ON-SITE WASTEWATER SYSTEM INSPECTION FORM

Re: Septic System Inspection (GQ #12-0228)  
Lot 4, Block 1, Dixon Heights Subdivision,  
1735 Pine Lane,  
El Paso County, Colorado

**SEPTIC DESIGN**

**Lot 4, Block 1,  
Dixon Heights Subdivision,  
1735 Pine Lane,  
El Paso County,  
Colorado**

Sheet: 1 of 4

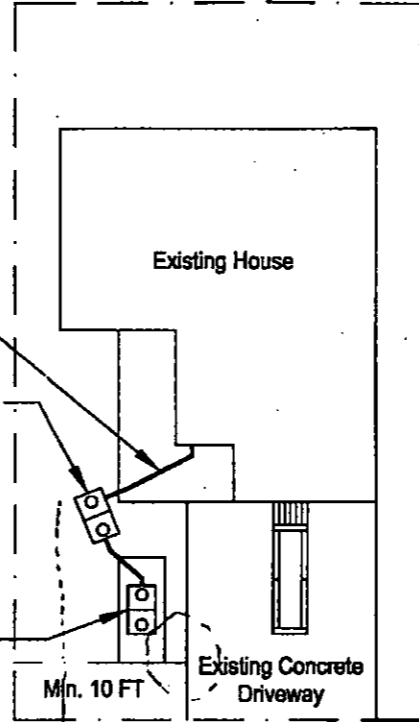
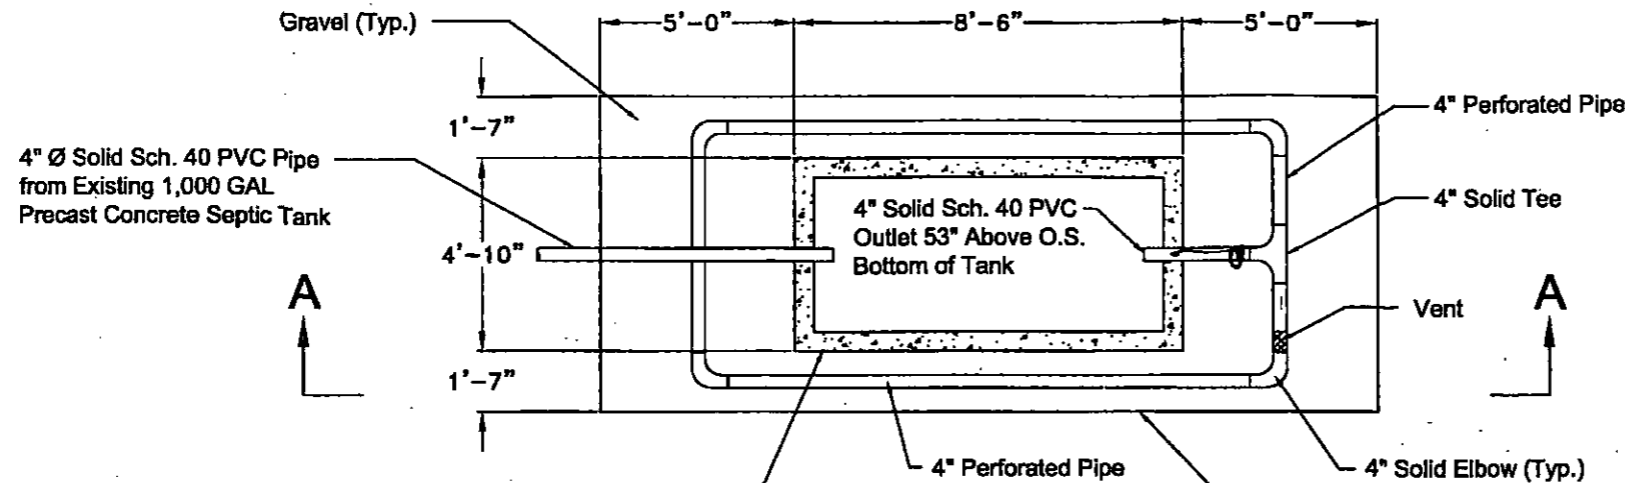
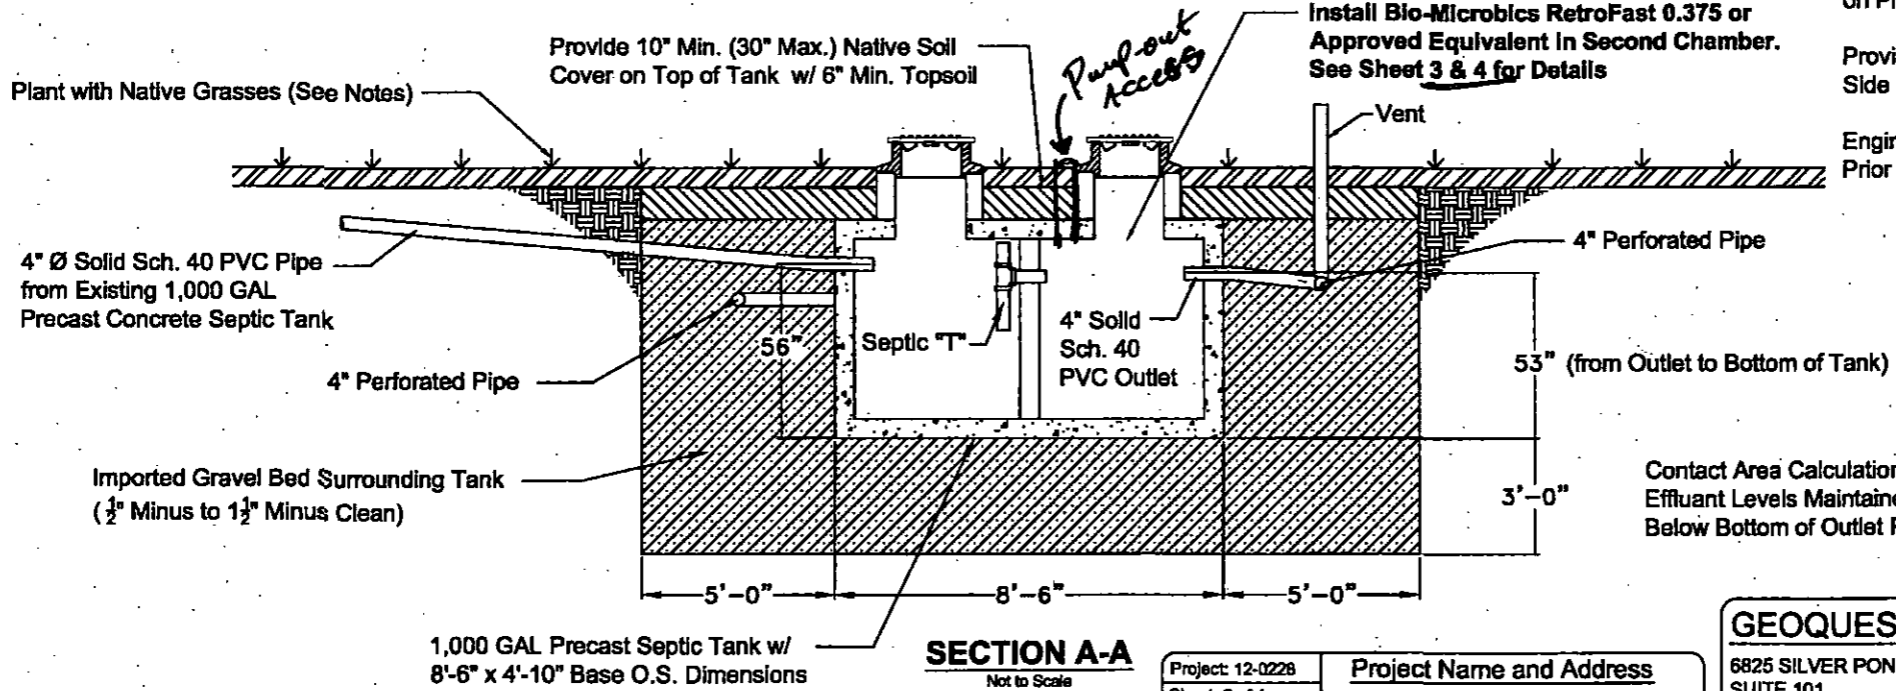
*- Arrowhead + pre-treatment is proposed due to lack of suitable area & an exist. site condition*

*- Note Loc. & construction proposal for exist. Ring system*

*- Show in Loc. of Ret. wall & Loc. of Ring system not shown flowers*

*- Physical Barriers Recommended.*  
Refer to Sheet 2, 3, & 4 for Details.

**Special Note:** Existing Failing Drywell to be Removed and Replaced with Proposed System. Remove All Contaminated Material in Area of Existing Failing Septic System. Arrowhead System to be Utilized at this Site Due to Existing Site Restrictions and Failing Drywell.

Existing 1,000 GAL Precast Concrete Septic Tank; Effluent Filter Recommended on Outlet of Existing Septic Tank

Physical Barrier Recommended between Existing Driveway and the Soil Treatment Area
